**PUBLIC HEARING
COMMUNICATION**

**RE: New Community Area Block 41 Secondary Plan Study, City of Vaughan
City File # 26.4.2
Our File # PAR 29981**

The following letter is provided on behalf of TransCanada Pipelines Limited ("TransCanada") to provide City staff and members of Council with our comments on the New Community Area Block 41 Secondary Plan (the "Block 41 Plan") as requested with the release of the draft to the public on March 13th, 2019. Given the limited time within which to review and provide comments, we reserve our right to provide additional comments following the public meeting, if necessary.

Figure No.: 4-1

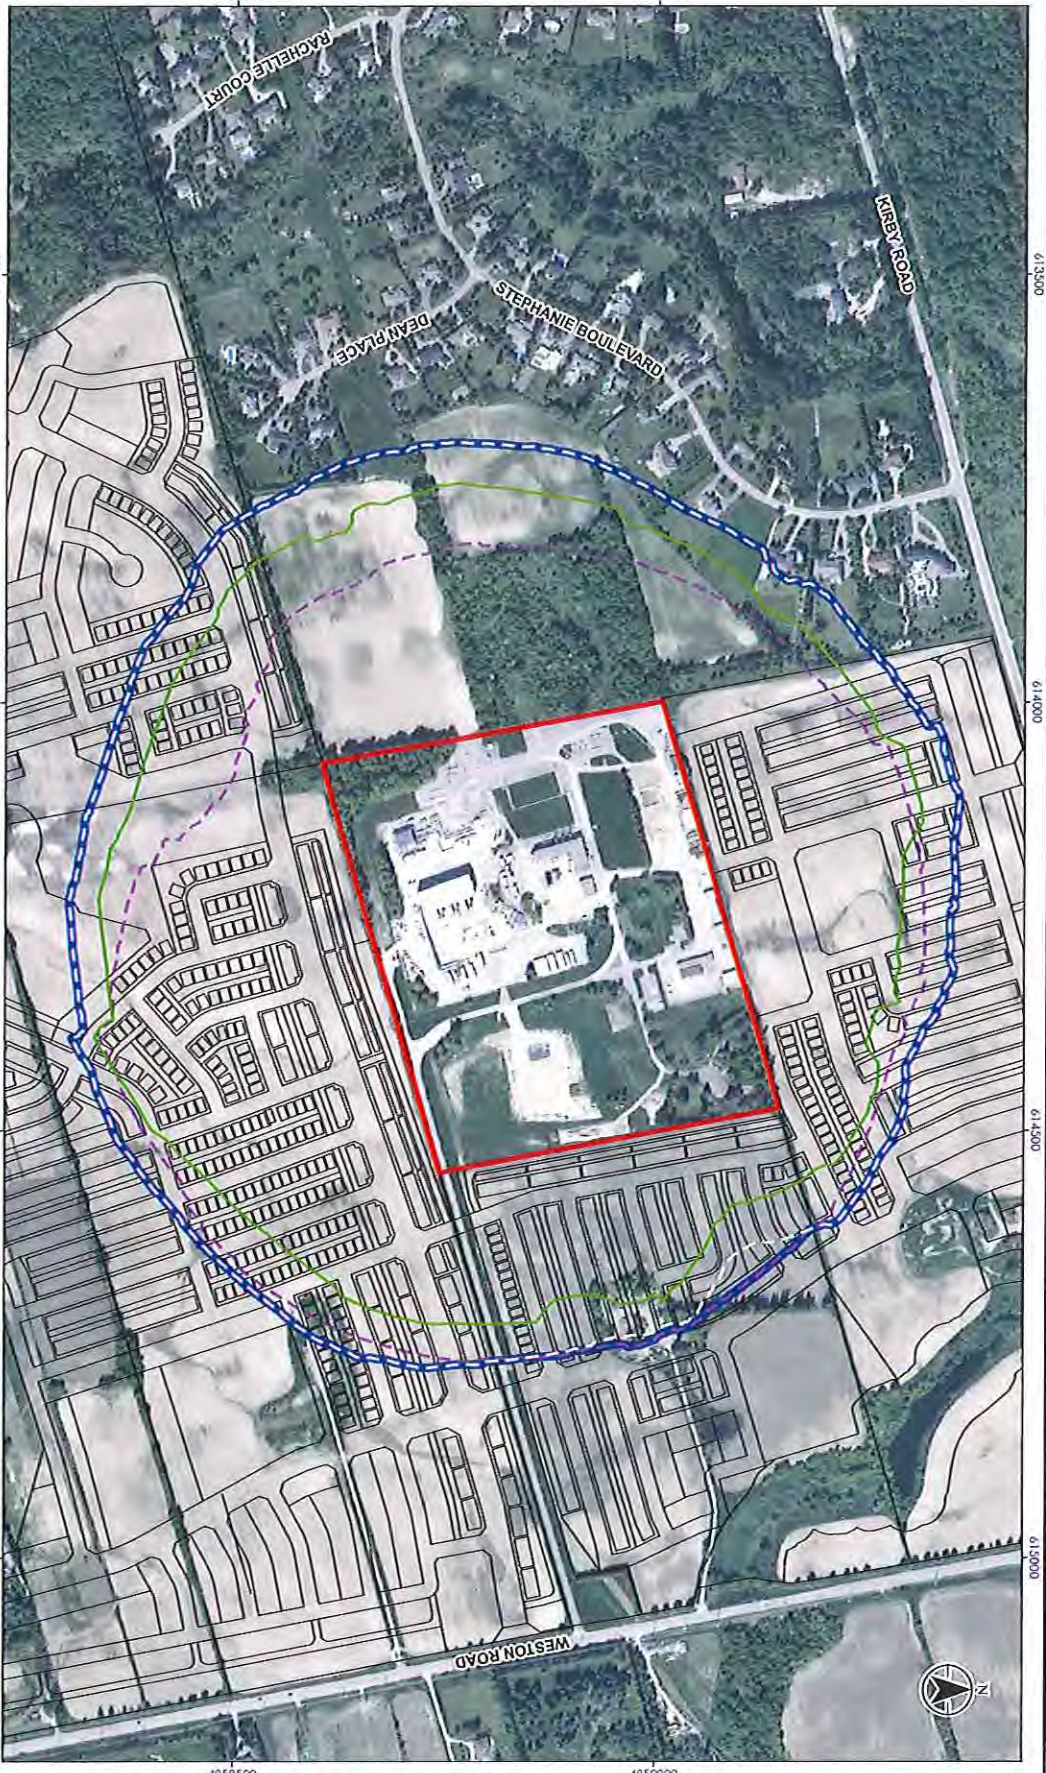
The separation distance for noise sensitive land use around Station 130 without gas cooler barriers (which were proposed in the Valcoustics Memorandum) is shown in Figure 4-1. The separation distance (blue outlined) follows the combined 43 dBA isopleth (white contour line) and 65 dBC isopleth (purple contour line).

For reference, the 45.5 dBA isopleth of Station 130, as predicted by Valcoustics with Stantec-recommended minimum mitigation measures required for compliance at existing receptors is also shown on Figure 4-1 (green contour line).

- Low frequency noise impacts were not adequately addressed by Valcoustics and present considerable risk with regard to noise-related annoyance
- Stantec recommends a minimum separation distance between Station 130 and development of any noise sensitive land use (refer to Figure 4-1 and Figure 4-2)

Figure No.
E-1

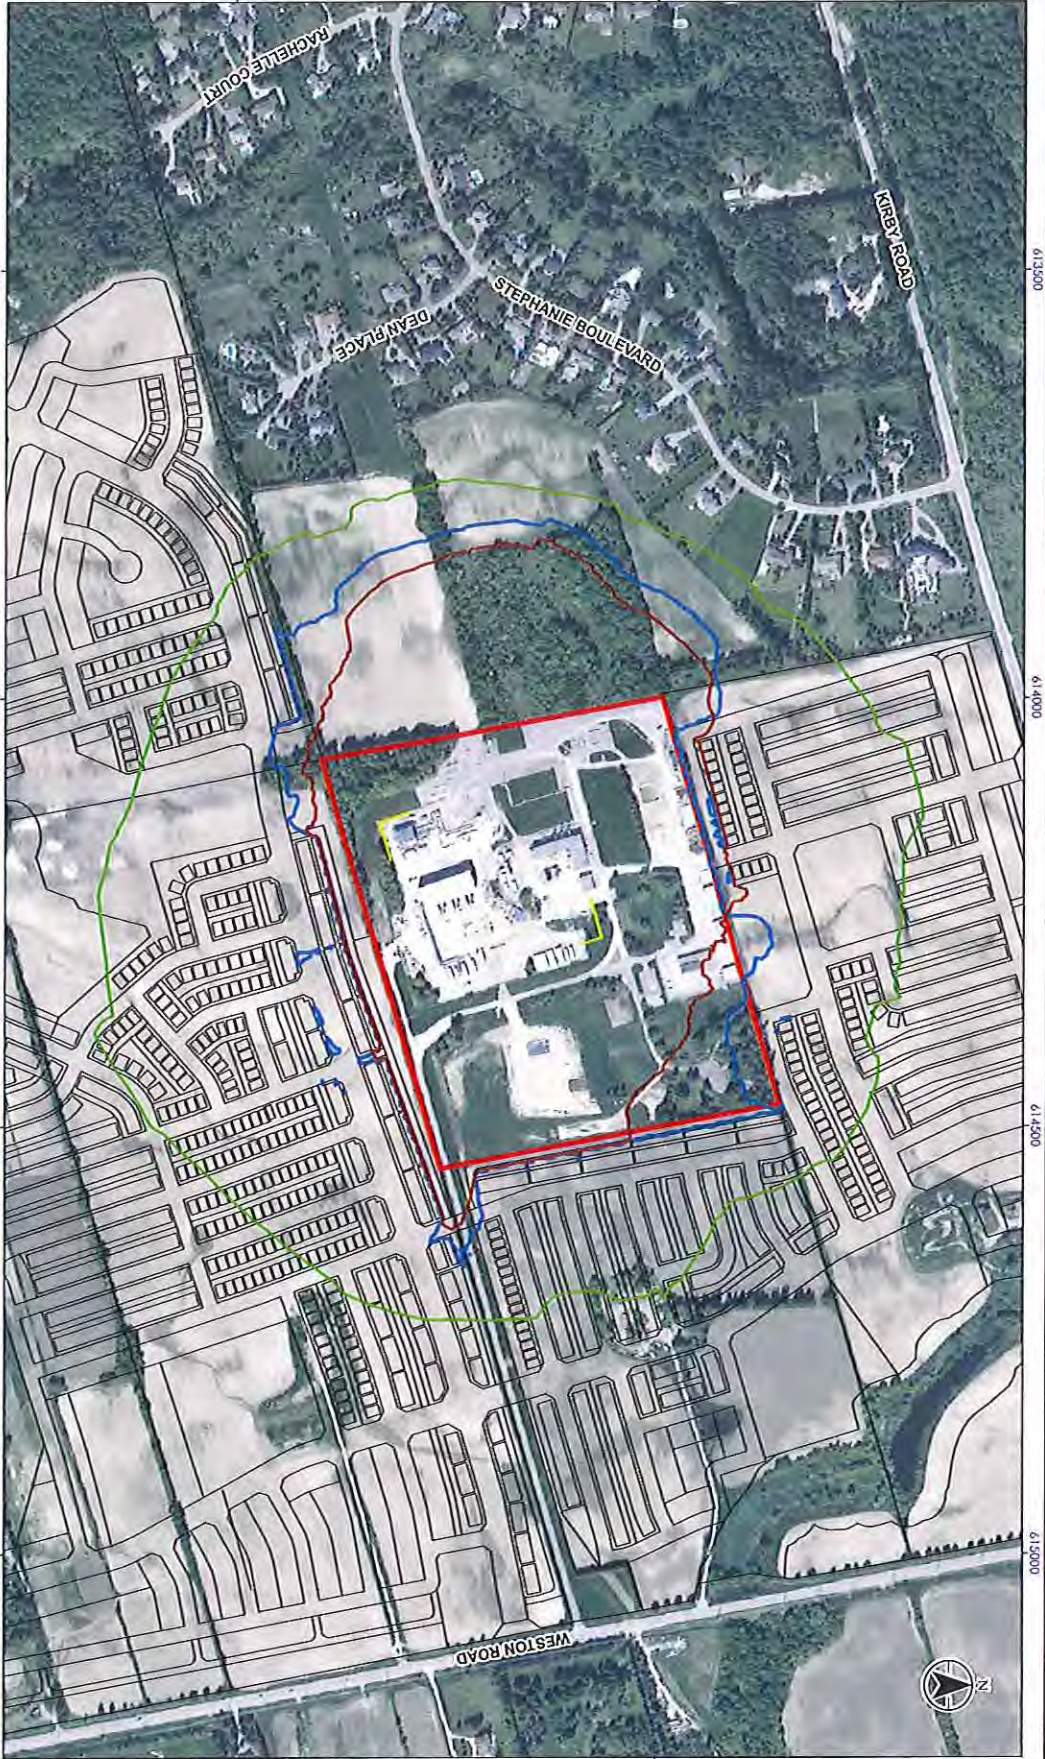
The Stantec noise model was run to predict A-weighted noise impacts of Station 130 with: Stantec mitigation measures, gas cooler barriers, and the New Community Area. The Stantec noise model predictions were compared with the Valcoustics noise model predictions, as shown in Figure E-1.

Figure E-1 shows the 45.5 dBA isopleth of Station 130, as predicted by the Valcoustics noise model (red contour line) and the 45.5 dBA isopleth of Station 130, as predicted by the Stantec noise model (blue contour line). For reference, the 45.5 dBA isopleth of Station 130, as predicted by the Valcoustics noise model with Stantec-recommended minimum mitigation measures required for compliance at existing receptors is also shown (green contour line).
